REGULATORY INFORMATION DISTRIBUTION SYSTEM (RIDS)

SUBJECT: Forwards response to NRC 900314 request for addl info re PRA, "Long Term Seismic Program."

Re: Docket No. 50-275, OL-DPR-80
Docket No. 50-323, OL-DPR-82
Diablo Canyon Units 1 and 2
Long Term Seismic Program - Probabilistic Risk Assessment

PG&E RESPONSE TO NRC'S MARCH 14, 1990 REQUEST

Figure F.3-1. Control Room Fire Scenario VB-1

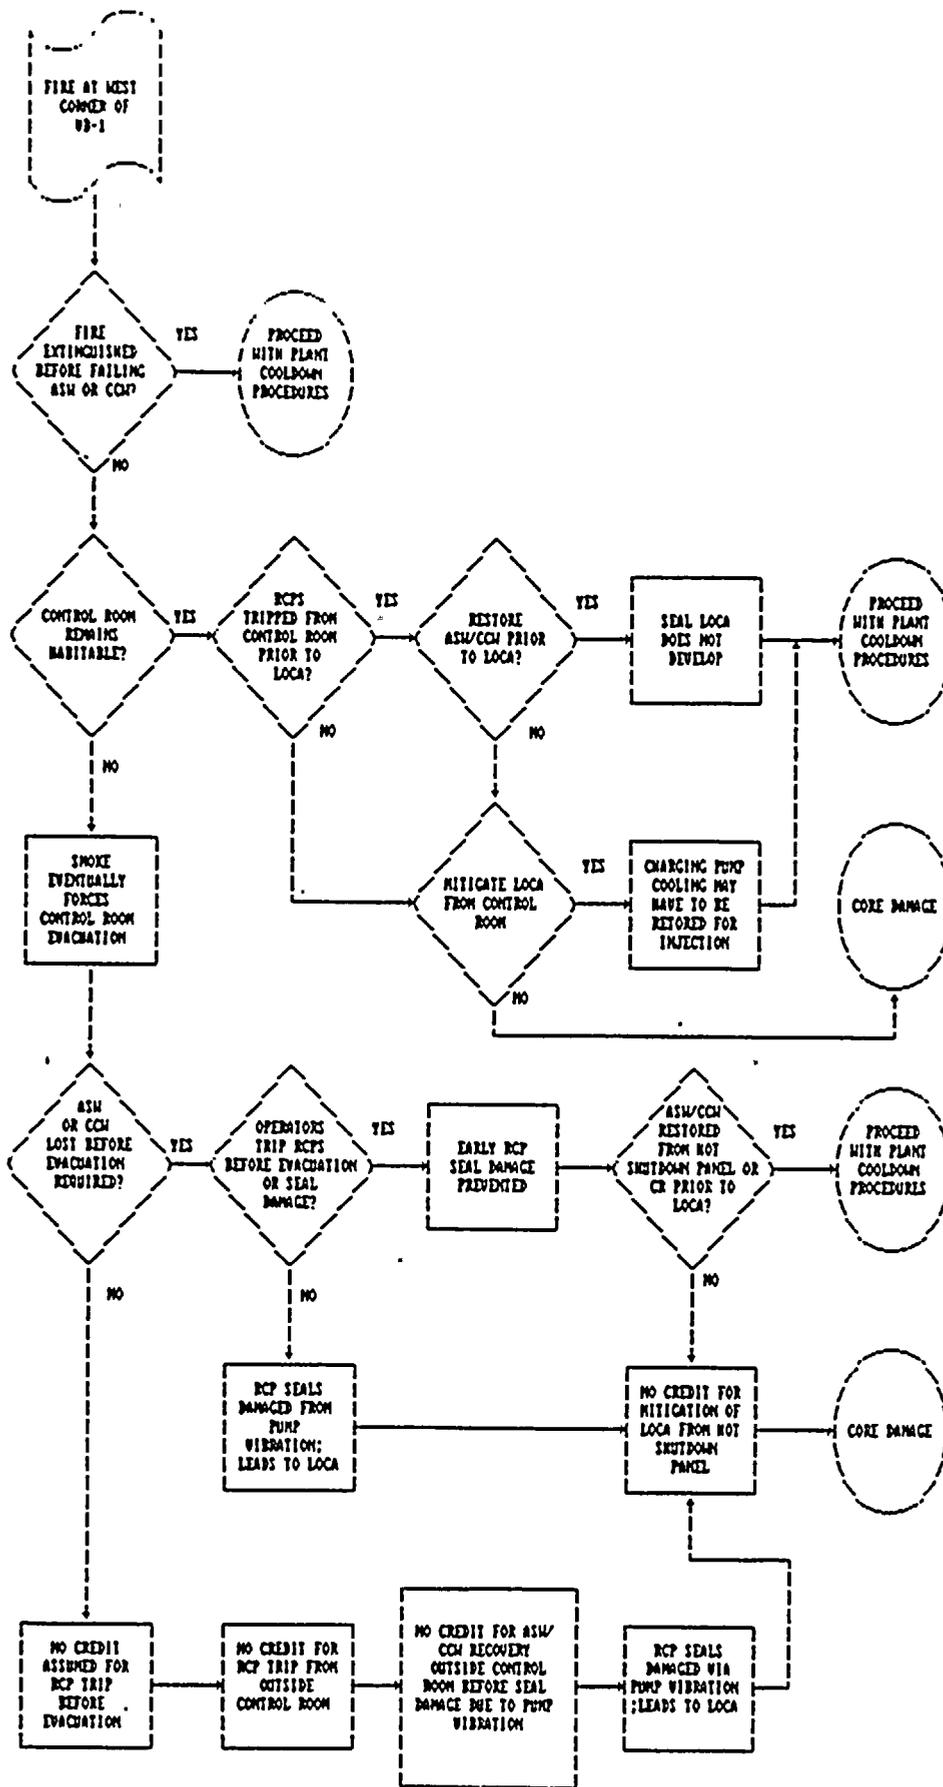
With respect to control room fire scenarios, it is not clear how the human actions at the hot shutdown panel and the associated timing are modeled for the cases where the RCPs are not tripped before evacuating the control room. Based on discussions with you, we conclude that reexamination of these scenarios is necessary. Please provide this reexamination and the following information:

For scenario VB-1, the flow diagram in Figure F.3-1 shows that the first operator action, after attempting to extinguish the fire, is to trip the RCPs within 10 minutes to prevent motor bearing damage after the loss of CCW flow. If the pumps are left running, shaft vibrations are assumed to develop when the bearings fail and cause damage to the pump seal assemblies, resulting in a small LOCA. The normally operating charging pump is assumed initially to remain operational, providing RCP seal injection. A second operator action required by scenario VB-1 (ZHEF12) is to restore ASW and CCW cooling from either the control room or the hot shutdown panel. Finally, a third action is to mitigate a LOCA, provided that the control room did not have to be evacuated. The quantification of these actions in scenario VB-1 is discussed in more detail in Section F.3.4.3.

Figure F.3-1 outlines the various sequences that make up scenario VB-1. First, the diagram indicates that the control room fires of concern affect the west corner of VB-1, which contains the controls for the ASW and CCW systems. The fire must be sufficiently severe to cause complete failure of CCW cooling to the RCPs and the charging pumps, which provide RCP seal injection flow. Interrelated to the severity of the fire, as measured by the amount of combustibles available, are the actions to extinguish the fire before it spreads. If the fire is suppressed before the ASW/CCW controls are affected, the impact of the fire is insignificant, and therefore not considered further. This is indicated in Figure F.3-1 by transferring it to the end state "proceed with plant cooldown procedures."
